N60087.AR.000785
NAS BRUNSWICK
5090.3a

April 14, 1999

Monitoring Event 13 Final Report for Site 9 at Naval Air Station, Brunswick, Maine

Gradient A, MW-80 to MW-72

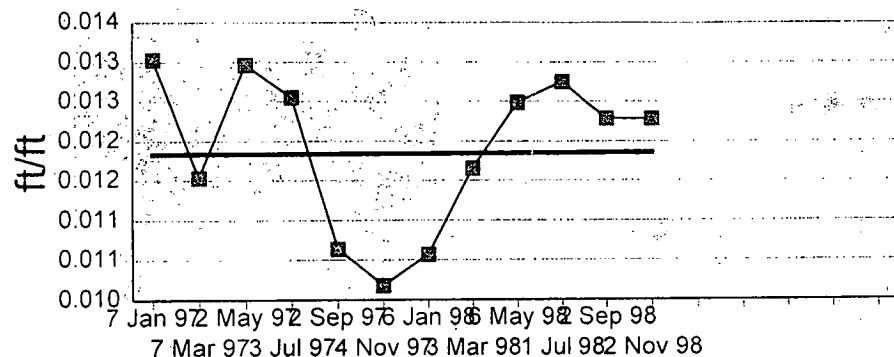
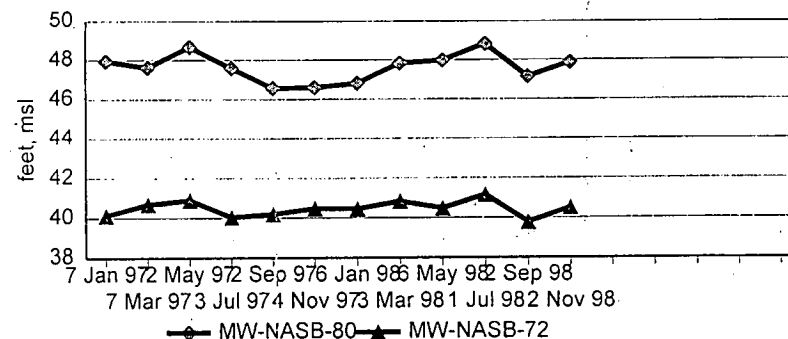
- ✓ 1. Groundwater Gradients. The gradient across the main flow direction of the site (from MW-NASB-80 to 72) is in the range it was before the retention ponds and a least mean squares regression line is nearly level across the whole period. The other two gradients aren't good measures because they plot data across the retention ponds. However, the relative northward gradient on the southern side of the upper retention pond has remained steady as well. It is also steeper than the main gradient by about double.
